Comment on Proposed Definition of Intersection

Benjamin Ross

April 22, 2021

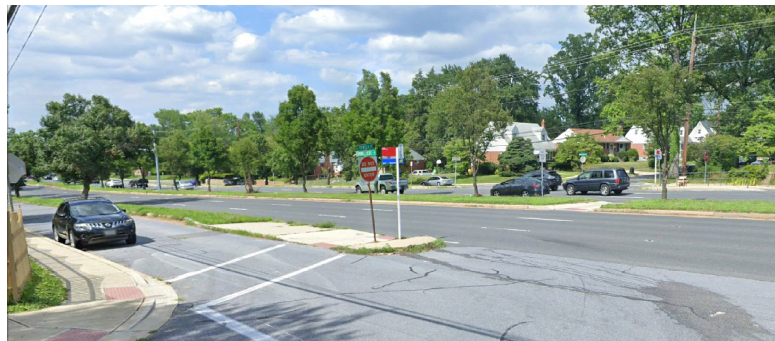
In recent years, Montgomery County DOT and Maryland SHA have tried to make walking safer in this area by upgrading crosswalks at bus stops. One of these crosswalks, across Connecticut Avenue at Isbell St., is shown here. The intersection was retrofitted with ADA-compliant ramps and an ADA-compliant median refuge.

As part of the improvements, the portion of the crosswalk in the service road was marked. However, in compliance with MUTCD §3B.18.09 (the parallel section to the new §3C.02), the agencies did not mark the crosswalk in the main travel lanes. Under the proposed definition, this would no longer be a crosswalk. The other upgraded crosswalks similarly lack markings in the travel lanes.
